SECTION 3

AGING MANAGEMENT REVIEW RESULTS

3.0 Applicant's Use of the Generic Aging Lessons Learned Report

Figure 4.5-1 Unit 2 Hoop Tendons, Projected Prestressing Force Trend

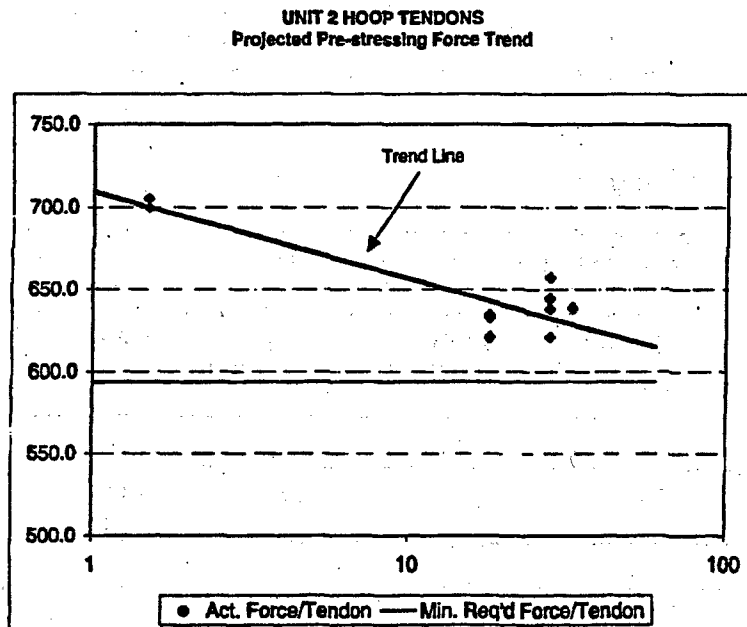
In response to RAI 4.5-1 items (2) and (3), the applicant provided the prestressing force plots *with the trend lines of the projected prestressing forces* for each group of tendons out to 60 years. The initial plots attached to LRA Section 4.5 were based on the lift-off testing of common tendons. This approach was not acceptable, as it was based on measurements of one tendon in a group. The staff recommended that the applicant develop the trend lines from all measured lift-off data, using a linear regression analysis. The applicant developed the trend lines using linear regression analysis and utilizing all measured lift-off force data. In its response, the applicant noted that this trend line information was based on draft calculations, and that the information will be resubmitted; if the final approved calculation revealed a different conclusion.

During a meeting on February 15, 2005, the staff indicated and the applicant agreed, that this response required further clarification. In its response, a clarification letter dated March 15, 2005, the applicant provided the corrected final plots showing the trend lines and the actual measured prestressing forces. Figure 4.5-1, shows a plot for Unit 2 hoop tendon reproduced for illustration purposes.

The staff found the process used in arriving at the trend lines to be in conformance with the provisions of NUREG-1800 Section 4.5.3.1.2 and, therefore, it is acceptable. The staff recognizes that the slopes of the trend lines could change as a result of the prestressing tendon measurements taken during future inspections. However, the applicant will evaluate the results pursuant to IWL-3221.1(c), and take corrective actions as stipulated in the LRA. The staff's concerns described in RAI 4.5-1 are resolved.
